April 2018
FL756AB
NHTSA #17V-761
Transport Canada #17-583

Subject: Brake Light Pressure Switches

Models Affected: Specific Freightliner Cascadia and Western Star 4700, 4900, 5700, 6900 model vehicles manufactured March 27, 2007, through November 21, 2017.

Fig. 7, Removing the Connector Pin

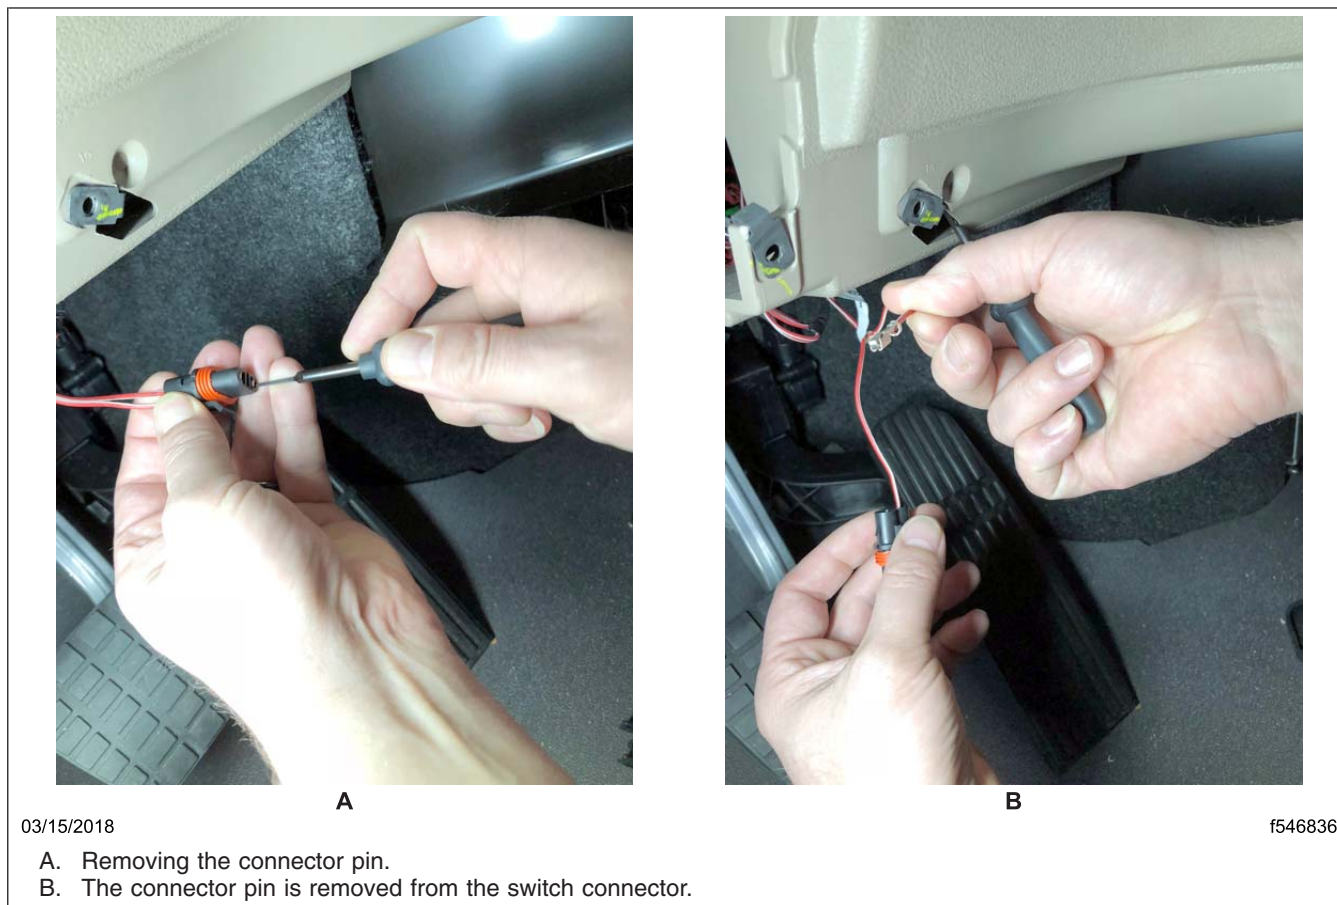
NOTE: It does not matter which pin is removed.

- Using the automotive connector terminal removal tool (DKI0CHA17002-1), remove one of the pins from the connector. See [Fig. 7](#).

Fig. 8, Retentioning the Pin Latch

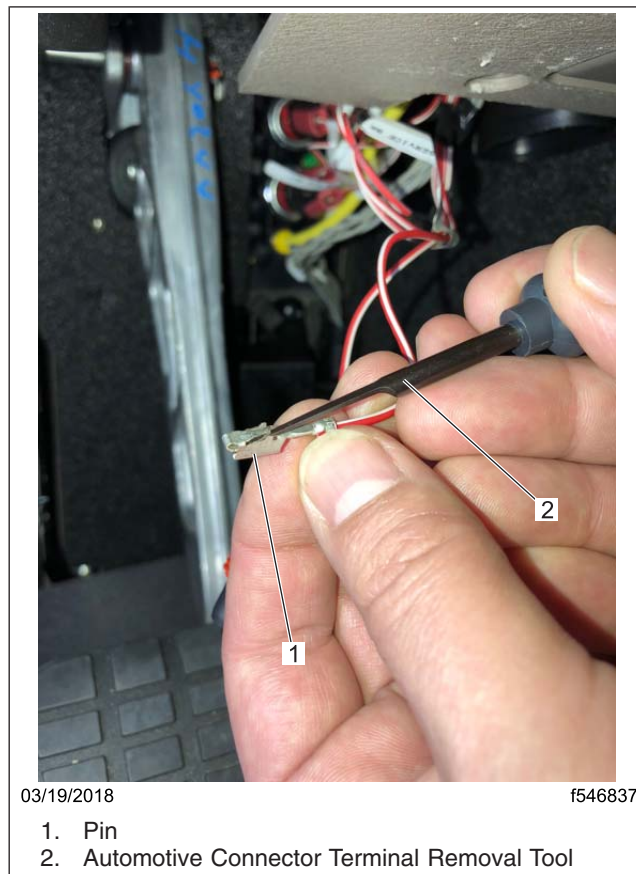
8. Cut the green seal off of the pin that was removed.
9. With the seal removed, use the automotive connector terminal removal tool to retention the latch on the pin. If this is not done, the pin may not latch and could push out when the connector is installed. See [Fig. 8](#).

10. Install the pin in the back of the connector. Pull on the wire to ensure the terminal is seated properly. If the terminal does not lock in properly, repeat step 9.
11. Install the connector back cover.
12. Connect the switch connector to the air pressure switch.
13. Using the three screws, install the throttle pedal cover.
14. Install the column cover.
